2011-2015 F-59 Commercial Stripped Chass

This article supersedes TSB **16-0014** update the warranty base part number.

Figure 1 - Article 16-0059

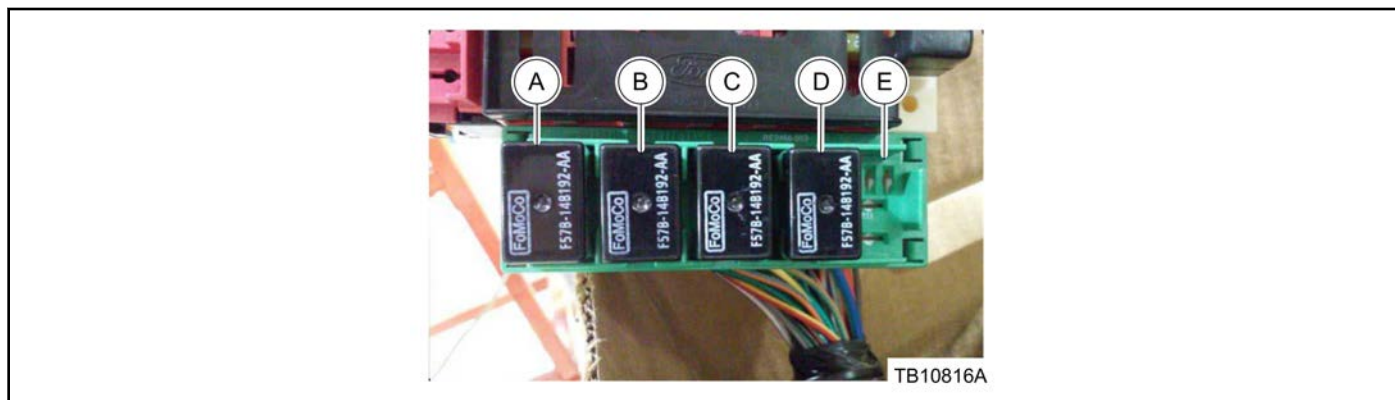
1. Is the hazard lighting, turn signal operation or TT lighting not functioning properly?
 - a. Yes - proceed to step 2.
 - b. No - this article does not apply. Refer to Workshop Manual (WSM), Section 417-01 for normal diagnostics.
2. Locate the central junction box (CJB) in the lower left side of dash. Remove and discard the following relays: (Figure 1)

- A - Trailer Tow Right Turn
 - B - Trailer Tow Left Turn
 - C - Right Turn
 - D - Left Turn
 - E - Empty
3. Install new 4-terminal relays in the CJB in positions A, B, C and D. (Figure 1)

PART NUMBER	PART NAME
9L2Z-14N089-A	Terminal Relay Assembly (4 req)
